Access Compliance Report

Public Rights-of-Way

Intersection ID: 10038358	Main Street: SOUTH_BV	Cross Street: N/A	Location: SE
ADA ID: E8D925560B66	Ramp Type: Directional1	Initial Pass/Fail: Pass	Overall Compliance: No
		Severity Score: 2.5

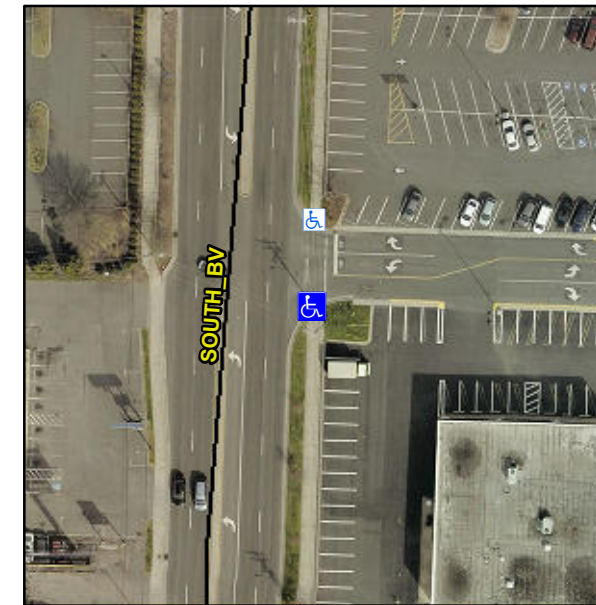
**R304.2.2-Perp, R304.3.2-Para,
R304.5.3, R304.5.2, R305.1.4**

Compliance	Description	Data	Compliance	Description	Data
N/A	Ramp Length (in)	128.0	No	Grade Break?	No
Yes	Ramp Width (in)	95.0	N/A	Grade Break Slope (%)	3.5
Yes	Ramp Slope (%)	5.2	N/A	Grade Break XSlope (%)	0.2
Yes	Ramp XSlope (%)	0.4			
Yes	Flare Type LT	N/A	Yes	Flare Type RT	N/A
N/A	Flare Slope LT (%)	N/A	N/A	Flare Slope RT (%)	N/A
N/A	Flare Traversable LT?	No	N/A	Flare Traversable RT?	No
Yes	Landing Length (in)	82.0	Yes	DWS Provided?	Yes
Yes	Landing Width (in)	96.0	Yes	DWS Contrast?	Yes
No	Landing Slope (%)	2.3	Yes	DWS Length (in)	24.0
No	Landing X Slope (%)	2.2	No	DWS Full Width?	No
N/A	Landing Curb? (Y/N)	N/A	Yes	DWS Offset LT (in)	33.0
N/A	Shared Landing?	No	Yes	DWS Offset RT (in)	1.0
Yes	Gutter Ponding?	No	Yes	Gutter Slope (%)	2.2
Yes	Gutter Lip Ht (in)	0.0	Yes	Gutter X Slope (%)	1.0
N/A	Painted X Walk1?	Yes		Road Slope (%)	1.6
	X Walk 1 Direction	To NW		Road X Slope (%)	1.5
	X Walk 1 Width (in)	111.0		Clear Space?	Yes

Remove & Replace Entire Ramp.
